Confederated Tribes and Bands  
of the Yakama Nation

June 21, 2011

This letter summarizes the Yakama Nation's comments and concerns regarding the proposed action alternatives presented in the Draft Environmental Impact Statement for the Disposal of Greater-Than-Class C (GTCC) Low-Level Radioactive Waste and GTCC-Like Waste (DOE/EIS-0375-D). Our review of the Draft GTCC EIS has found that it is deficient in a number of areas, and will require substantial revisions. Key elements must be thoroughly redone in order for the revised Draft GTCC EIS to be considered technically and legally adequate. We have provided a detailed evaluation of the elements in the attachments that accompany this letter.

**Figure 1: IEER's modeling results for trench disposal of GTCC and GTCC-like waste in a trench at Hanford**

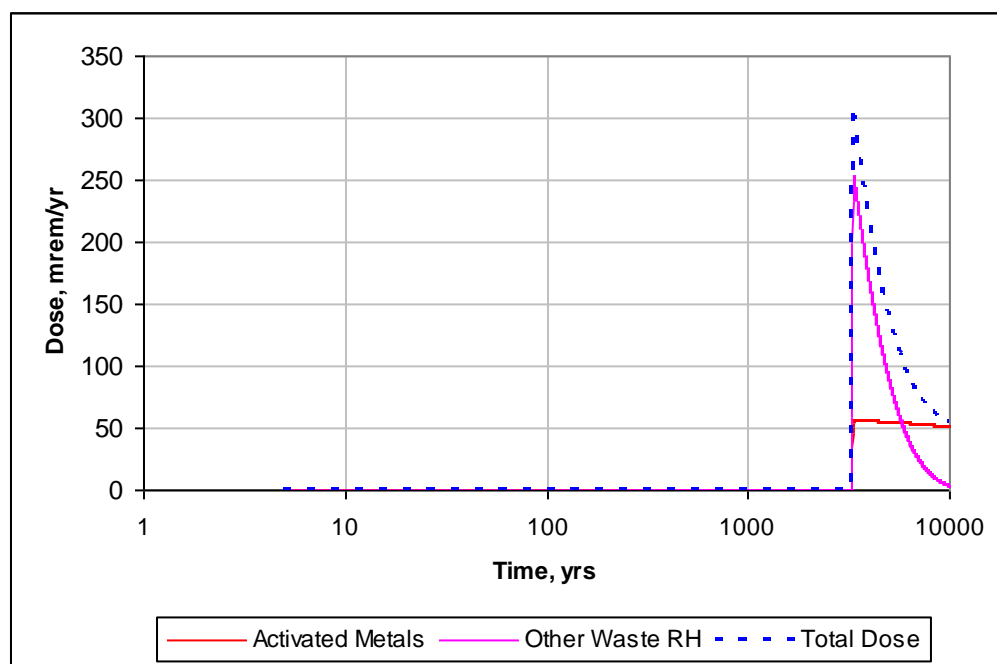
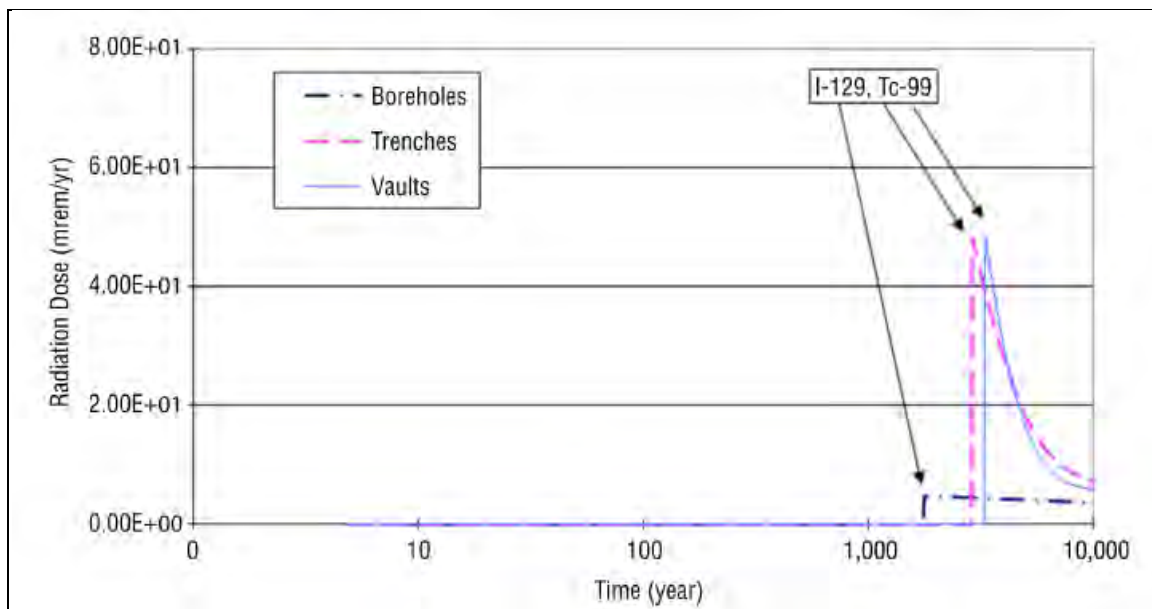
Figure 1 shows the results of IEER's verification calculations using the DOE assumptions so far as we could determine them from the Draft EIS (see Appendix A for more details).

As can be seen from Figure 1, IEER's peak dose estimate using the DOE's parameters so far as they could be determined is about 300 millirem per year. The activated metals dose is about 50 millirem and the Other Waste - RH dose is about 250 millirem. The total peak dose is about six times the DOE's estimate of 48 millirem noted above. Figure 2 below shows the results of DOE's trench disposal modeling in more detail.

**Figure 3: Total Dose for the Different Distances to the Well** (Note: Base case distance to the well is 300 m, which is in between the case of very close (25 m) to the site boundary and 600 m).

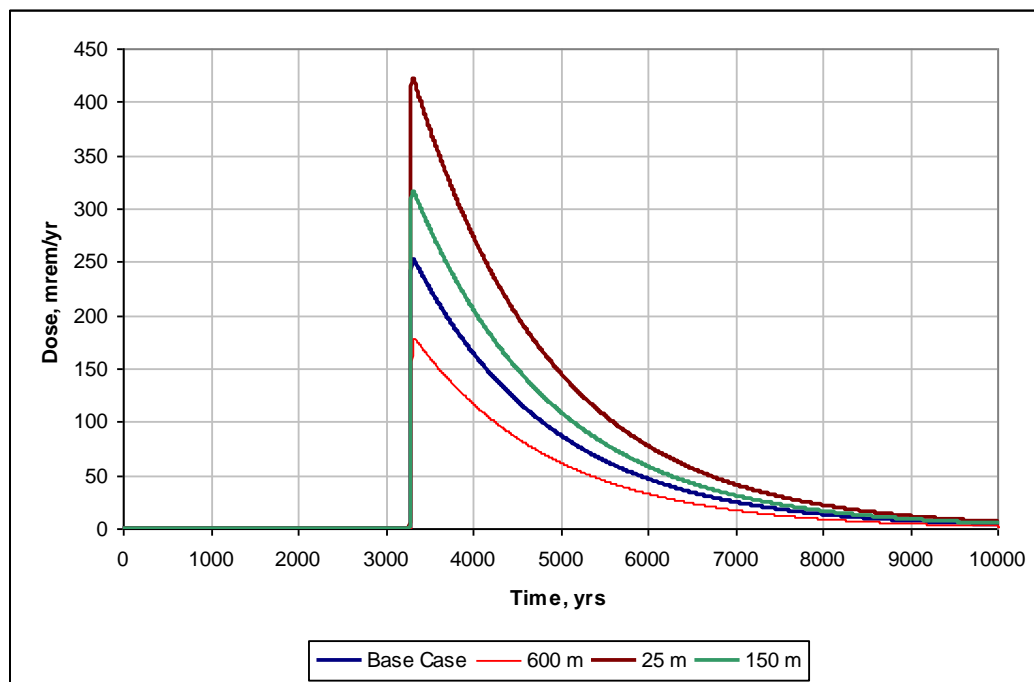
It is clear that the variation of a single parameter increases the dose from the most important component of the waste in terms of peak dose (Other Waste - RH) from about 250 mrem/year to over 400 mrem per year.

**Figure 4: Base Case and Conservative Case for the Other Waste - RH category.** (Note: The green line represents the total of activated metals and Other Waste - RH. The red line is Other Waste - RH alone)

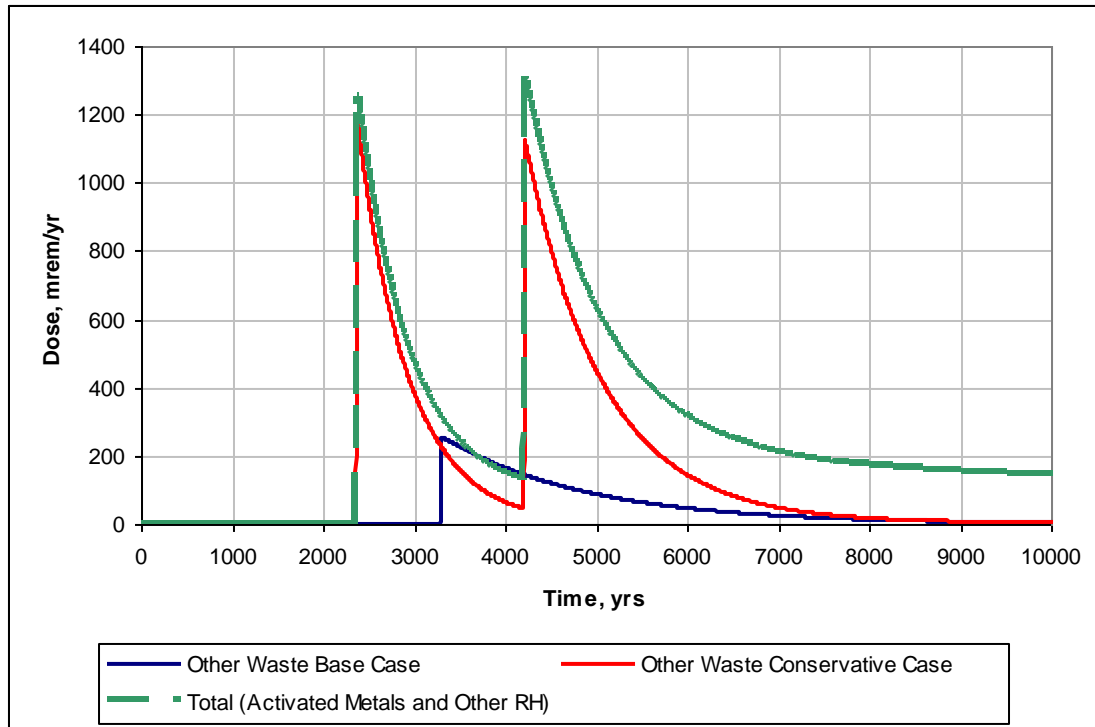
When all parameters are varied the upper limit of dose increases by about a factor of four for total dose and by more than a factor of four for the Other Waste - RH category. See Figure 4 below and Appendix A for more details.

**Figure 5. Base Case and Cover Erosion and Aquatic Food Scenario for the Other Waste RH Category (red line). The green line shows dose for the total source term (other waste plus activated metals)**

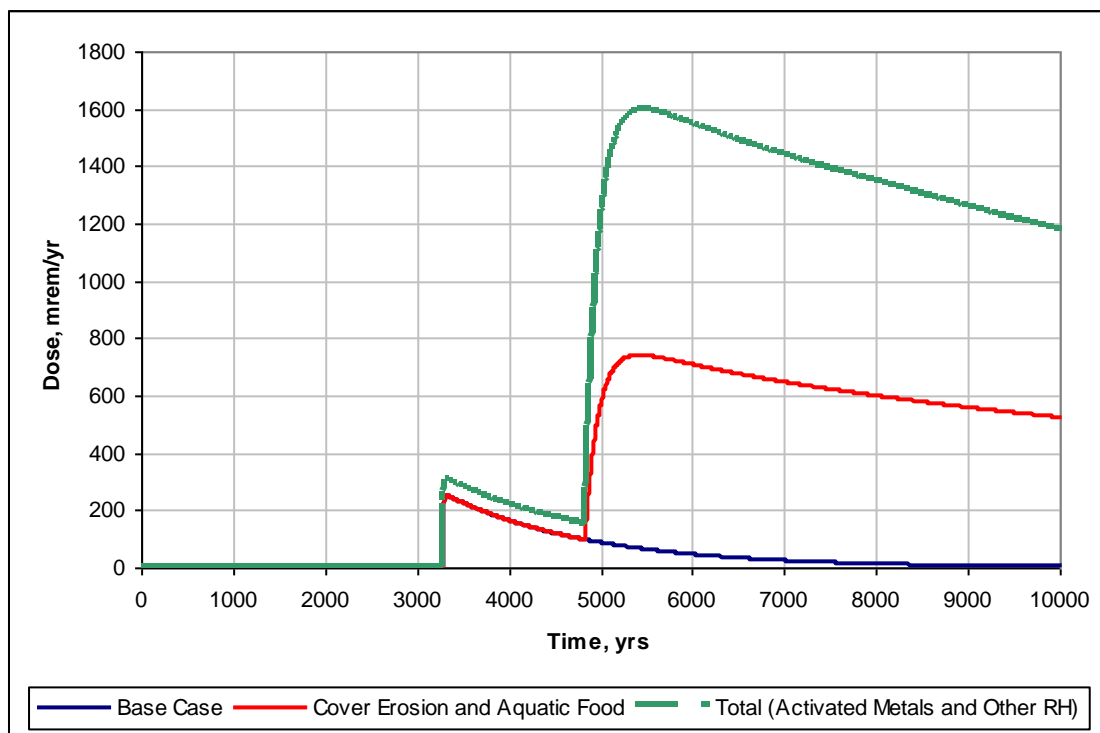
An erosion rate of 1 mm/year results in the 5-meter thick trench cover being completely eroded in 5,000 years. Hence, at that point, rain and snow contact the waste, some of which gets washed off into surface water. This means that the dose from the aquatic food pathway is significantly increased. Figure 5 shows the results for the cover erosion scenario. The red line shows the dose from Other Waste RH and the green line shows the total dose. Note that even though the other parameters, such as infiltration have been maintained the same as in the base case IEER model, there is a second peak dose, after the cover erodes, of about 1,600 mrem/year at somewhat over 5,000 years after disposal;

this is much greater than the first peak, which occurs due to groundwater use. The main reason for the higher second peak is the dose from consuming surface water and aquatic food from surface water sources.

Further, the major contributors to the second peak are the transuranic radionuclides Cm-245, Pu-239, and Pu-240. This is completely different from the Tc-99 and I-129 doses, which are important in the earlier peak.

**Figure 6: Borehole Land Disposal Alternative for the Group 1 Stored Other Waste - RH Category**

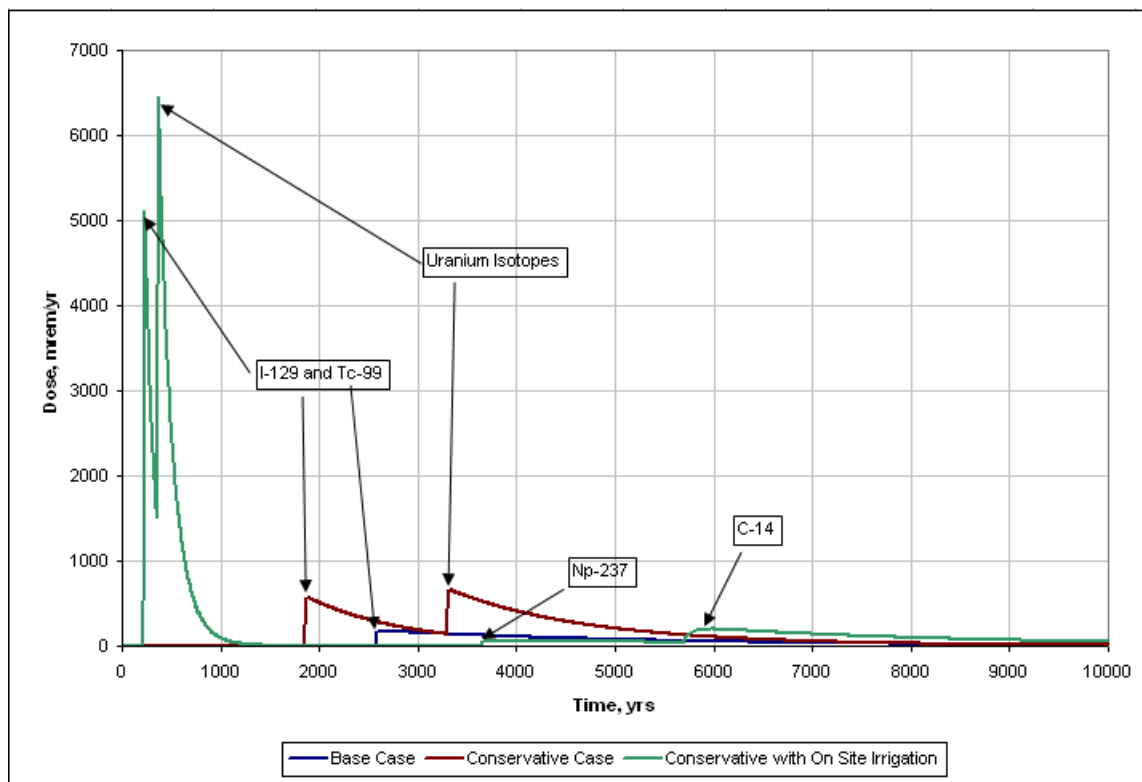
IEER also tested the case of borehole disposal in several variations with a farmer living at the site boundary, using water that has passed next to the waste, but not over it, and finally using water that has passed through the waste. Infiltration rates were also varied. Figure 6 shows the results. The lowest peak dose was 177 mrem/year about 2,650 years in the future while the

case of using irrigation from the site had two peaks – one of 5,050 mrem/year 235 years in the future due to I-129 and Tc-99 and one at 6,431 mrem/year 372 years into the future due to uranium isotopes. For context, the Draft EIS's estimate of peak dose due to borehole disposal was just 4.8 mrem/year – 37 times lower than the lowest borehole estimate when institutional controls are relaxed and more than 1,300 times lower when there is total loss of institutional control and memory.

Note that the highest dose in the irrigation scenario case is due to uranium – a strong reminder that large amounts of uranium are unsuitable for disposal even in boreholes as much as 40 m deep. So long as the disposal is relatively shallow and water is available beneath the disposal, the method is likely to be a problem from the point of view of a resident farmer and loss of institutional control.

**Figure 16. Base Case and Conservative Case for the Other Waste RH Category**

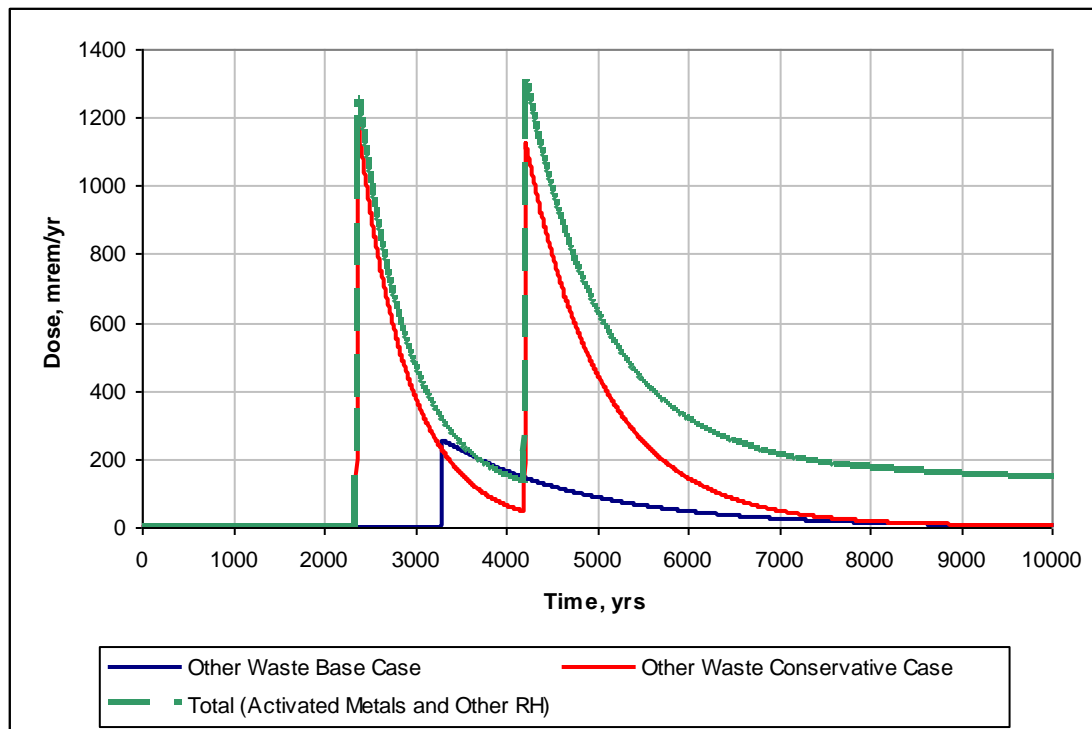
Figure 16 compares the base case to the conservative case for the other waste RH category. Figure 17 compares the base case to the conservative case for the activated metals category. The total dose (activated metal and other waste RH) is plotted in both figures as well. In both cases, the peak doses in conservative case are more than 4 times higher.

**Figure 20. Base Case and Cover Erosion and Aquatic Food Scenario for the Other Waste Category (red line). The green line shows dose for the total source term (other waste plus activated metals)**

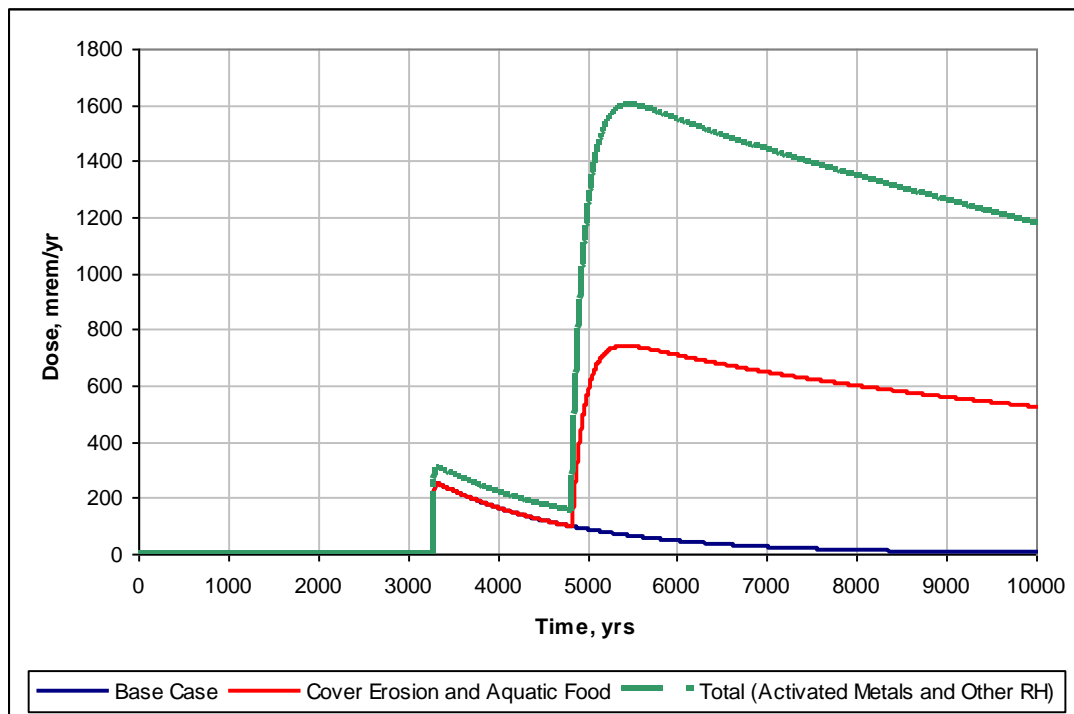
The results of this scenario are shown in Figures 20 and 21 for the other waste RH category and activated metals category respectively. The total dose (the sum of activated metals and other waste RH doses) are also plotted in these figures.

As can be seen from these figures, the cover erosion and aquatic food scenario significantly affects the total dose. In both cases, there is a second dose peak, which is 6.5 times higher than the 1<sup>st</sup> peak. The differences begin to surface when the cover starts to disappear (around year 5,000). At this moment the waste becomes exposed at the surface and is a subject of the surface water transport. The major contributors to the second peak are Cm-245, Pu-239, and Pu-240. The major pathway is the aquatic pathway.
